ID0000175
Response to Comments
Hecla
Lucky Friday Mine

EPA, Region 10
May 2019

Prepared by:
Cindi Godsey, EPA

BLM-based Criteria Comparison

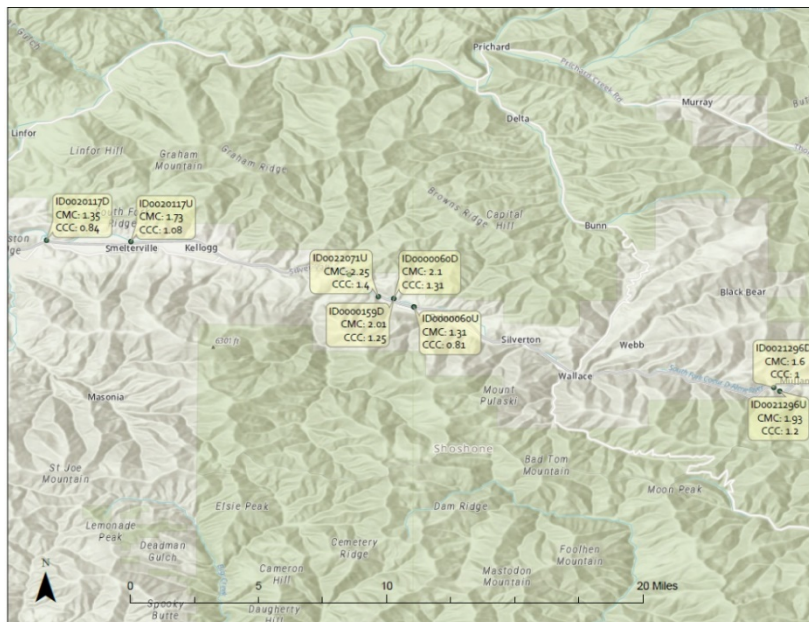
4. **Comment:** Part I.B (page 4): LFU has concerns with the approach for calculating the copper BLM based effluent limits, as presented in the Draft Permit and Fact Sheet. LFU understands the BLM-based copper effluent limits were developed using a regional classification system, as described in Statewide Monitoring for Inputs to the Copper Biotic Ligand Model (2017). However, LFU has the following concerns with the approach:

- The Mountain Stream class criteria are overly conservative for the SFCdAR near LFU. The Draft Fact sheet (pg. 71) notes that background concentrations of Cu are higher than the BLM criteria, with the average dissolved copper concentration of 1.21 ug/L above Outfall 002 and 0.69 ug/L above Outfall 003 over the monitoring period from 2012-2016. However, 10 years of site-specific bioassessment data show stream aquatic community equal to regional reference streams, indicating the Mountain Stream criteria are likely overly conservative. Based on the above discussion, LFU requests that the approach to use default regional input values for calculating the copper BLM-based effluent limits be reconsidered. LFU requests that the hardness-based copper effluent limits remain effective until after adequate site-specific data can be collected and site specific BLM criteria can be calculated during the five year compliance schedule period. Additionally, as per the Implementation Guidance for the Idaho Copper Criteria for Aquatic Life (2017), flow-tiered NPDES permit limitations are an acceptable implementation tool for copper Biotic Ligand Model (BLM)-based limits. Due to the extremely low BLM-based criteria and potential variability of BLM input parameters, LFU requests that flow-tiered limits be considered when defensible site-specific BLM based effluent limits are established in the Permit.

Response: The Fact Sheet specified that the BLM based effluent limitations would only be included in the final permit if EPA approved DEQ’s submission of the new WQS prior to EPA finalizing the permit. This approval occurred on May 2, 2019. Therefore, the applicable WQS in place for CWA purposes is the copper BLM WQS. The Fact Sheet also stated that since the ambient background concentration of copper exceeded the BLM criteria, no mixing zone could be authorized for copper.

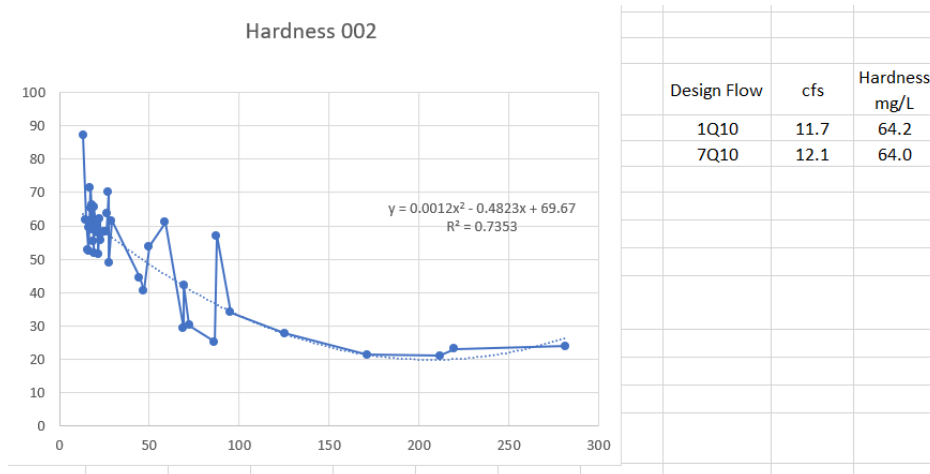
35. **Comment:** Please explain why EPA declined to analyze the full record of monitoring data for receiving water quality, outfall flow rate, effluent characterization, and critical low flow. EPA's Fact Sheet indicates the following analyses were based off varying date ranges of monitoring data Hecla collected pursuant to its current NPDES permit:

Hecla's current NPDES permit was issued in 2003. So, EPA has the benefit of well over a decade of monitoring data that should inform the development of Hecla's updated permit. For example, analyzing another year's worth of data (or more) could change EPA's calculation of the 99th percentile outfall flow rate. Similarly, another year's worth of data (or more) could reveal higher or lower potential maximum and minimum constituent levels in Hecla's effluent. And, changes to either or both of these variables could significantly affect EPA's determination of effluent limits and monitoring requirements. But rather than analyze all the data, EPA chose to limit its analysis to 4 years of data in some cases, without providing a reasonable basis for this decision.

We request EPA re-analyze receiving water quality, outfall flow rate, effluent characterization, and critical low flow based on the complete record of Hecla's monitoring data recorded since its current permit became effective.

Response: It is true that EPA did not utilize all the data from the latest permit term for the four categories listed above but there are valid reasons why this occurred. As the Fact Sheet contained the justification for several including the use of effluent data and outfall flow only since 2013 since the facility installed treatment just prior to a shutdown in 2012. EPA agreed with LFU that the data during 2012 may not be representative of the current operations and used only data after that point. Critical flows are based on 10 years (a 1Q10 being the lowest flow in a 10 year period while a 7Q10 is the lowest running 7 day average flow during a 10 year period) so using the most recent 10 years (at the time the Fact Sheet was being developed) is reasonable. As for receiving water quality, that information was required to be submitted on an annual basis and EPA did not have anything more current at the time that the Fact Sheet was being developed.

Requested MDLs for Select Parameters

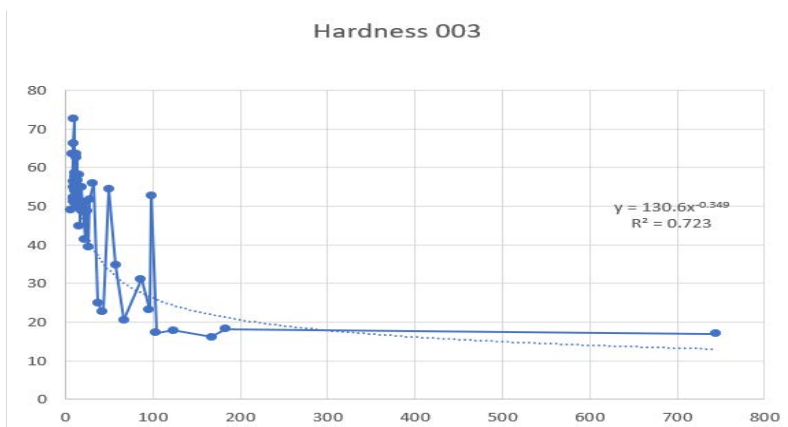
47. **Comment:** Part VI.C.4. (page 32): Table 16 of the Draft Fact Sheet provides the required MDLs for surface water monitoring. After consultation with their contract laboratory LFU has determined that the MDLs for calcium, magnesium and sodium provided in Table 16, are not attainable. Therefore, LFU requests the following MDLs be substituted for those provided in Table 16:

Response: EPA consulted the DEQ BLM Guidance for the required detection values necessary to determine site-specific BLM criteria since monitoring for several parameters is included specifically for criteria development. The BLM Guidance includes Reporting Limits and, these are comparable to a Minimum Level rather than an MDL. EPA has revised Table 5 in the final permit to contain a column of Reporting Limits for the parameters necessary to derive the BLM criteria.
